Product Change Notification / JAON-15XJYR211

CCB 5299 Final Notice: Qualification of MTAI as an additional final test site for MIC79110-4.2YML-TR and MIC79110YML-TR catalog part numbers (CPN) available in 10L VDFN (3x3x0.9mm) package.

PCN #: JAON-15XJYR211

Pre and Post Change Summary

Pre and Post Change Summary – Carrier Tape

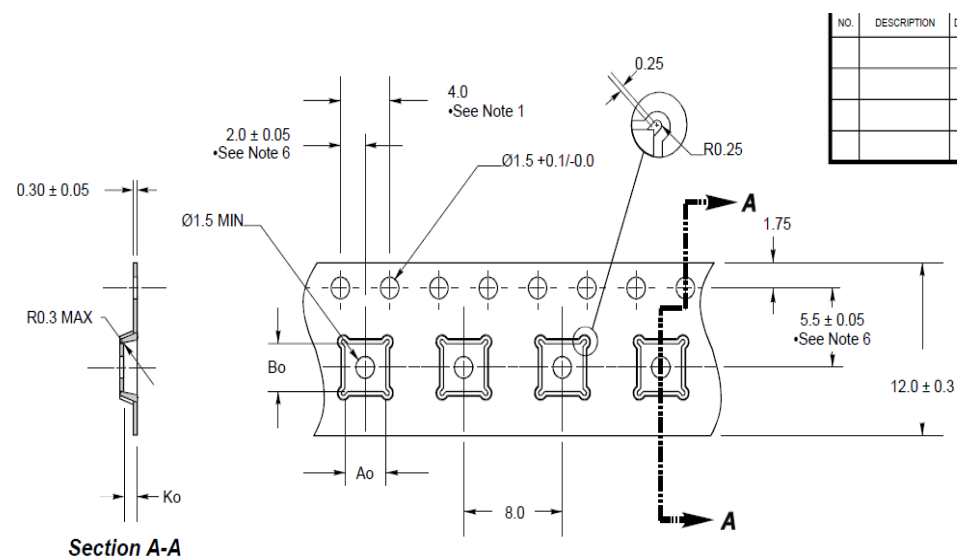
UNIS

Section A-A

Ao = 3.3 mm
Bo = 3.3 mm
Ko = 1.1 mm

Supplier	W (mm.) ±0.3 or Specific	P (mm.) ±0.1 or Specific	A ₀ ±0.1 or Specific	B ₀ ±0.1 or Specific	K ₀ ±0.1 or Specific	Thickness ±0.05
Supplier A	12	8	3.30	3.30	1.00	0.30
Supplier B	12	8	3.30	3.30	1.10	0.30

Pre and Post Change Summary – Cover Tape

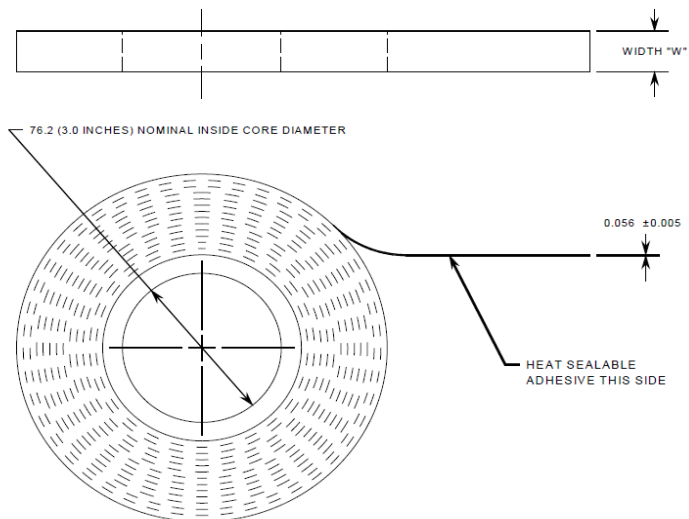
Plant	Package	Carrier Tape Width	Cover Tape Width	Thickness of Cover Tape	Color of Cover Tape	Sealing mythology
UNIS	10L VDFN 3x3	12mm	9.2mm	0.056mm	Clear	Heat sealing
MTAI	10L VDFN 3x3	12mm	9.05+0.05/-0.15mm	0.050 ±0.010mm	Clear	Heat sealing

MTAI

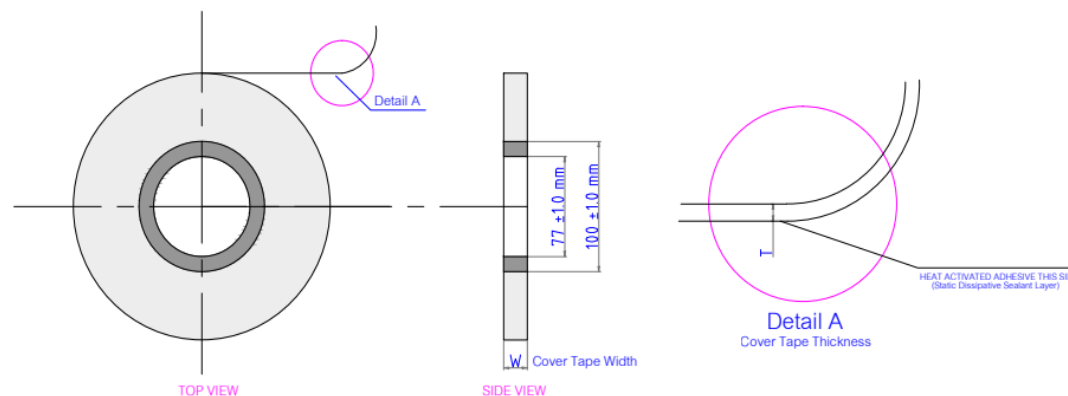
Plant	Package	Carrier Tape Width	Cover Tape Width	Thickness of Cover Tape	Color of Cover Tape	Sealing mythology
UNIS	10L VDFN 3x3	12mm	9.2mm	0.056mm	Clear	Heat sealing
MTAI	10L VDFN 3x3	12mm	9.05+0.05/-0.15mm	0.050 ± 0.010mm	Clear	Heat sealing

Pre and Post Change Summary - Reel

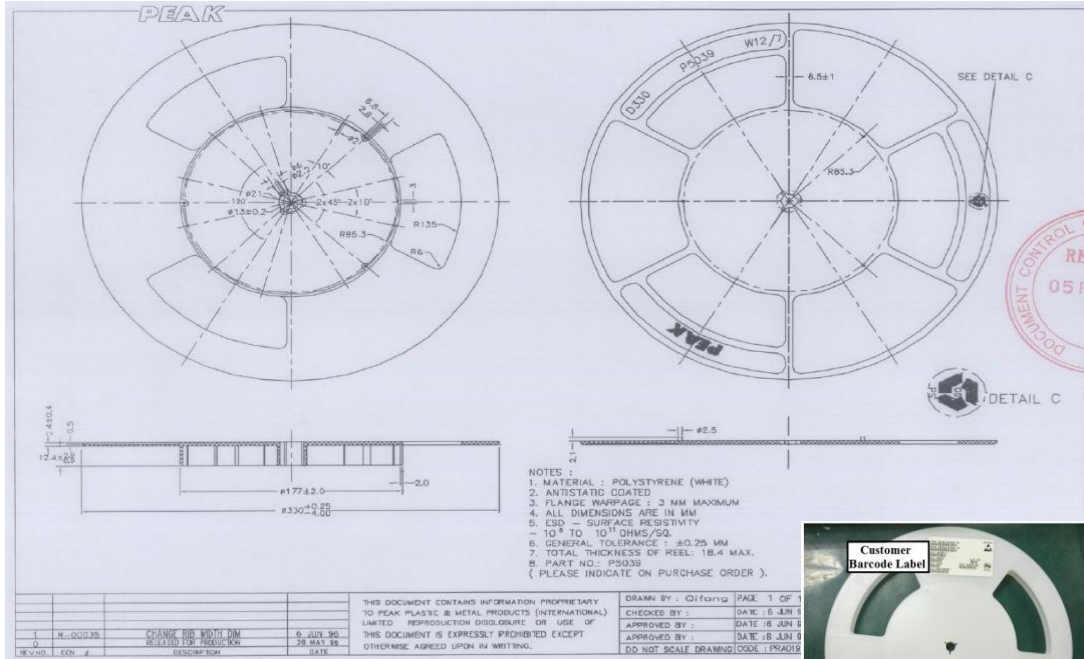
Color: White

Plant	Package	Carrier Tape Width	Reel Diameter (mm.)	Reel Hub Size (mm)	Reel Width Max (mm.)	Color
UNIS	08L VDFN 3x3	12mm	330 +4.0/-0.25	177 ±2.0	18.40	White
MTAI	10L VDFN 3x3	12mm	330 ±2.0	100 ±2.0	18.40	Dark Blue

MTAI

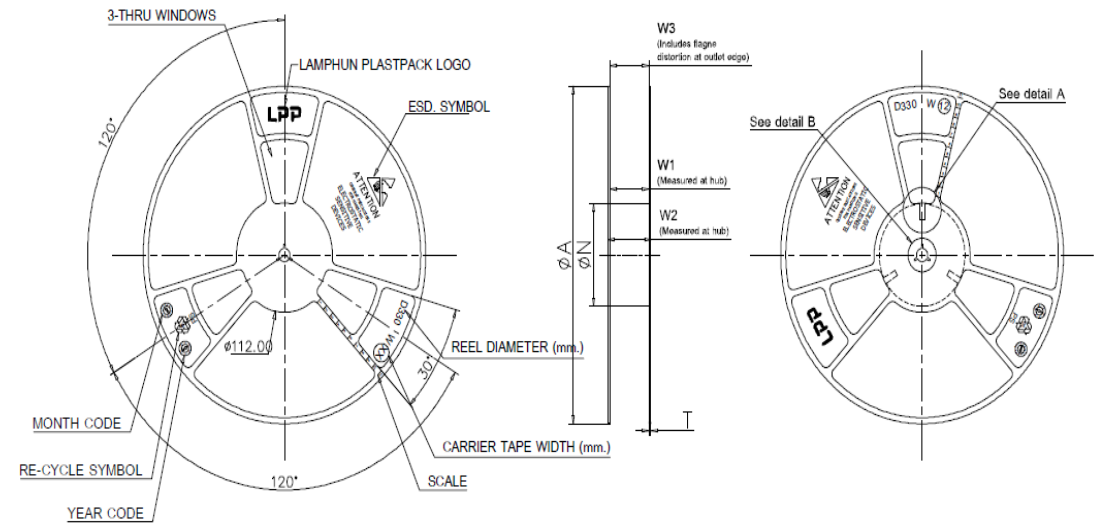
Color: Dark Blue

Pre and Post Change Summary – Packing Method

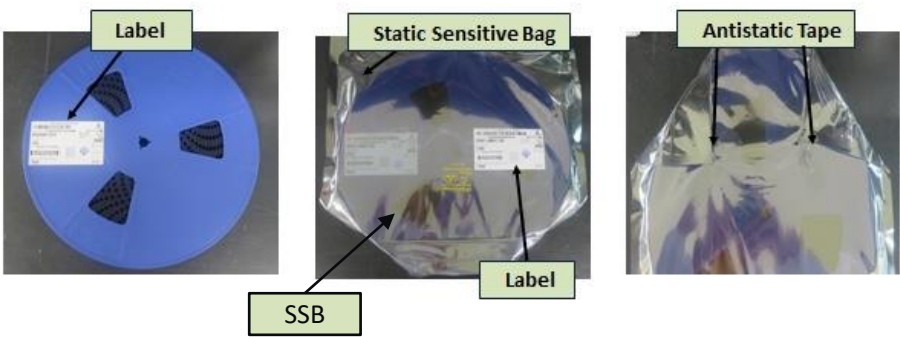
MSL-1 (No inner box)

Carton	Dimension W x L x H (cm)	Number of reel per carton
		Reel diameter (D) = 330mm
		Carrier Tape Width 12mm
M01-011 (TT)	36.5x38x39.5	15
M01-012 (B1)	35.5x35.5x2.8	1
M01-013 (B2)	35.5x35.5x4	2
M01-014 (B3)	35.5x35.5x6	3
M01-015 (B8)	35.5x35.5x16.5	8
